TOWN OF NEWBURGH
PLANNING BOARD
TECHNICAL REVIEW COMMENTS

PROJECT: TARSIO FAMILY SUBDIVISION
PROJECT NO.: 2015-08
PROJECT LOCATION: SECTION 39, BLOCK 1, LOT 21.1
PROJECT REPRESENTATIVE: ZEN DESIGN CONSULTANTS, INC.
REVIEW DATE: 10 JULY 2015
MEETING DATE: 16 JULY 2015

RE-SUBMISSION INFORMATION

SURVEYOR ANTHONY VALDINA, L.S.	ENGINEER WILLIAM MOREAU, P.E.	TARSIO FAMILY SUBDIVISION 5 LOT SUBDIVISION SURVEY PLAT SBL: 39-1-21.1 TOWN OF NEWBURGH, ORANGE COUNTY, NY
--	---	--

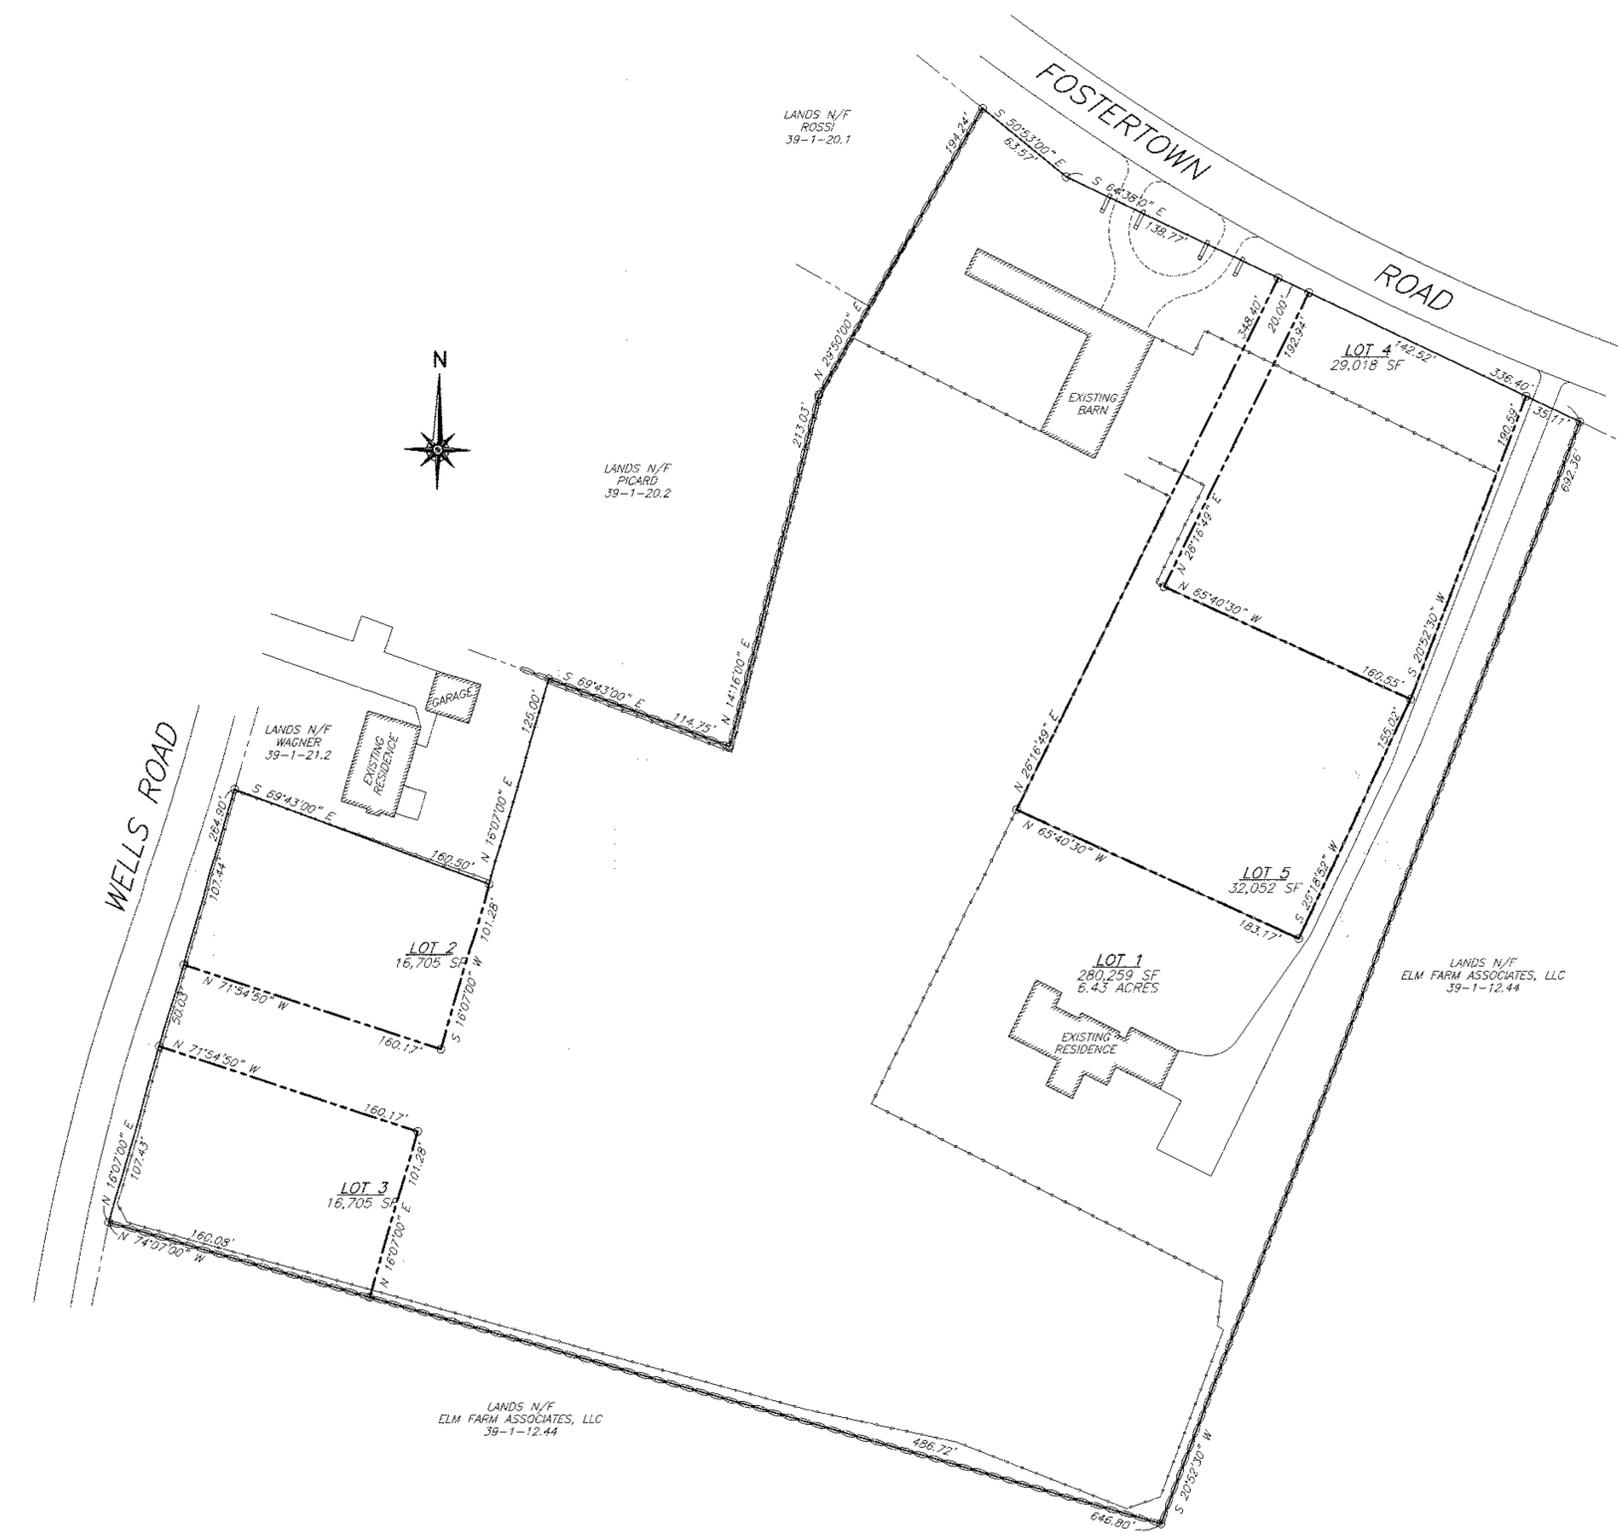
1. Existing barn within front yard along Fostertown Road may require a zoning variance.
A zoning variance has been received for this and for the accessory building size & height.

3. Sewer flow acceptance letter is required.
This is understood and will be acquired.
4. Lot 1 is served by an existing septic system. Providing sewer on the site will require connection of lot 1 to the sewer line, per Orange County Health Department requirements.
The plans have been changed removing the plan for the sewer extension.

ENGINEER WILLIAM MOREAU, P.E.		TARSIO FAMILY SUBDIVISION	
		5 LOT SUBDIVISION	
		LOT LAYOUT	
		SBL: 39-1-21.1	
		TOWN OF NEWBURGH, ORANGE COUNTY, NY	
DATE	SCALE	JOB NUMBER	SHEET NUMBER
10/14/2014	1" = 50'	14-004-TAR	2 OF 4

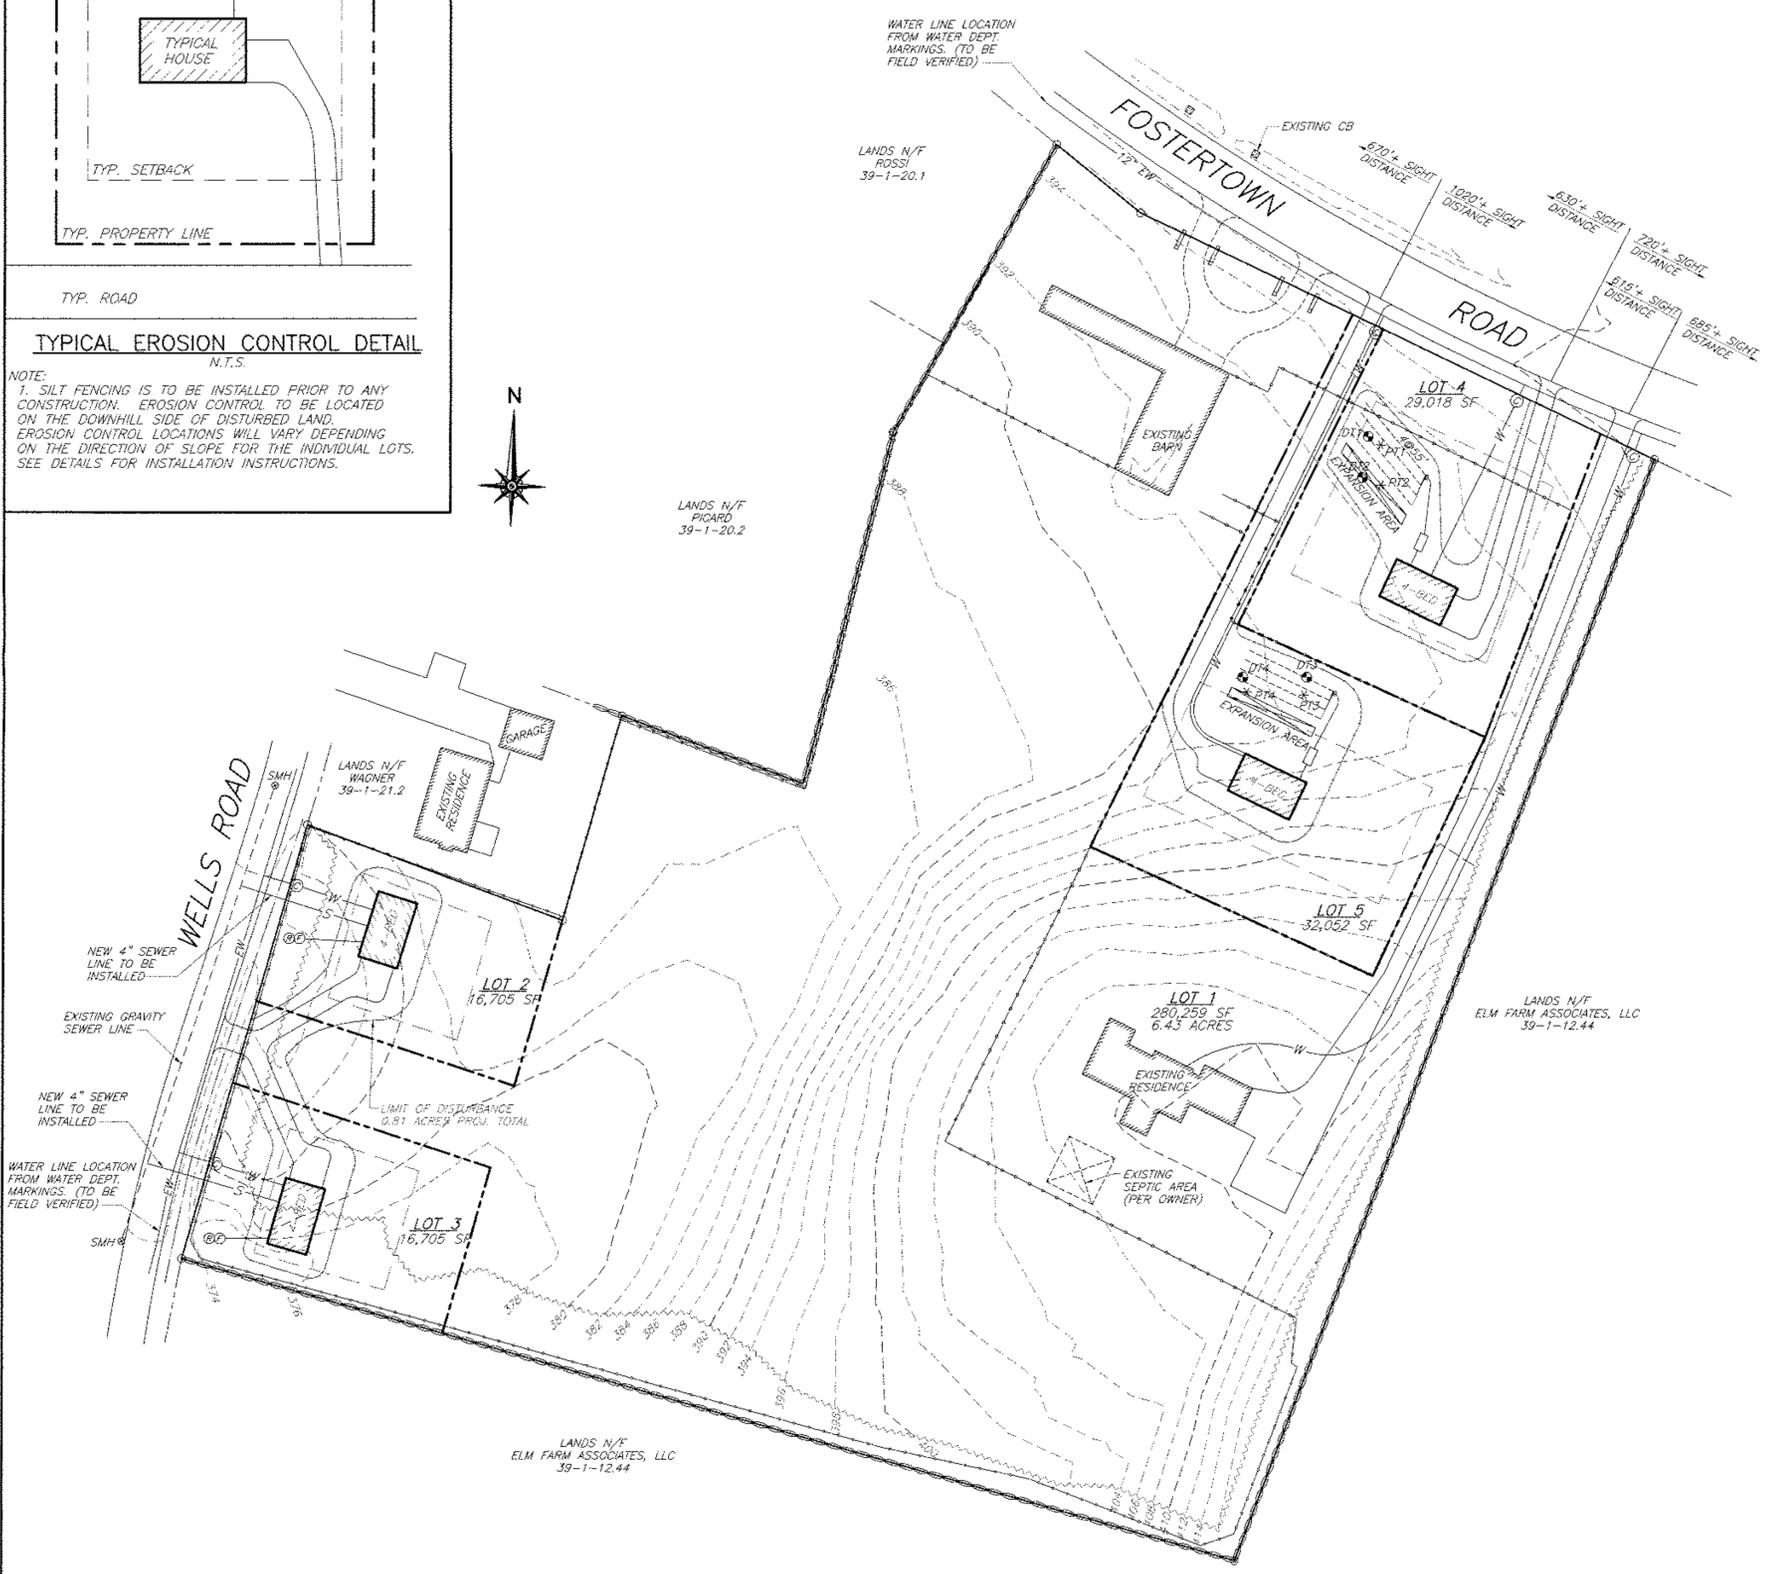
9. Staked hay bale detail should be removed from plans, not an acceptable practice.
This detail has been removed.
10. Limits of disturbance should be identified on the plans including acreage of disturbance to determine if SPDES permit is required.
A line designating the limits of disturbance has been added to the plan.

Re: Re: Tarsio Family Subdivision
Plans By: William Moreau.
Date: 10/14/14; Last Revised: 1/5/15
County Route 86 – Fostertown Rd
Sheet No.: 2 of 4 Five Lot Subdivision Plan,
Town of Newburgh, SBL: 39-1-21.1

Orange County Department of Public Works: Highway Engineering can conceptually accept the location of the driveway entrances for the proposed residential driveways.
